CHANGE ORDER NUMBER: 2

Project Name: Corridor C-SH 29 Bypass

Corridor C- SH29 Bypass Williamson County Project No. 23IFB67 Change Order No. 2

JONAH WATER S.U.D.
 WILLIAMSON COUNTY, TEXAS
 2020 - SH 29; CORRIDOR 'C', UTILITY ADJUSTMENTS
 STA. B-10+50 TO B-17+82

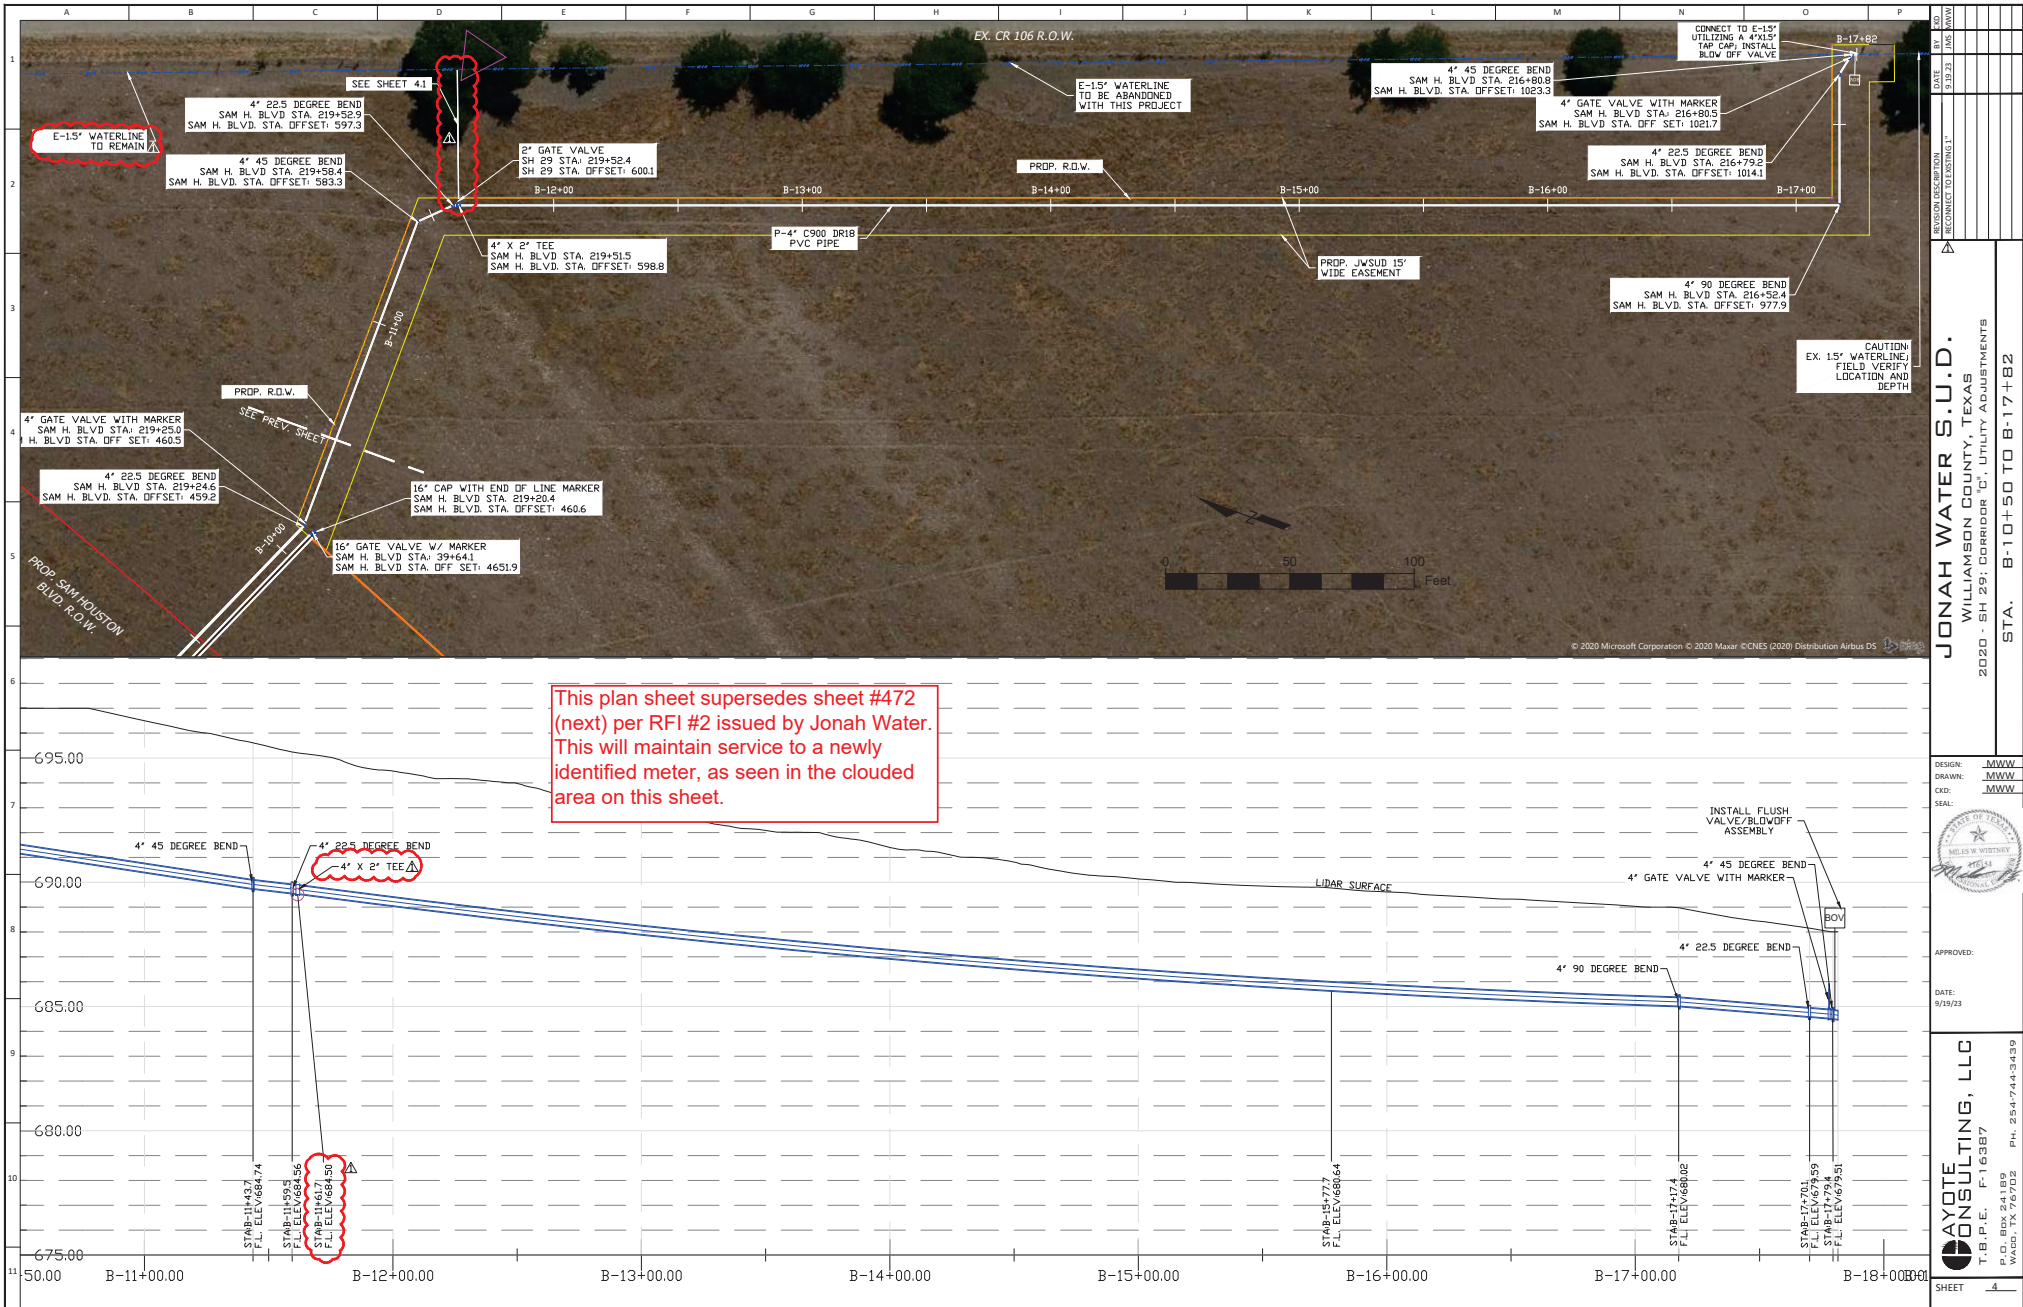
1B. Design Error or Omission. Other.: This Change Order compensates the contractor for maintaining an existing Jonah water meter that was not accounted for in the plans.

This Change Order compensates the Contractor for additional work related to maintaining an existing Jonah water service that was identified during the relocation of the new Jonah water line along CR 106 but was not accounted for in the plans. Per RFI 2, Jonah stated to maintain the existing service and provided revised plan sheets and additional quantities for this work.

Jonah's staff have identified an existing meter, that was not acknowledged in the current plan set.

Jonah's staff have identified an existing meter, that was not acknowledged on the current plans set. Please see the revised and add plan sheet 4 and the added plan sheet 4.1 to the project plans, to maintain service to this existing meter.

See the revised sheet #4 and the added plan sheet 4.1 to the project plans, to maintain service to this existing meter.

Below are the Qty changes that these revised sheets include.

REVISION	DATE	BY	DESCRIPTION
1	9/19/23	MS	MMW
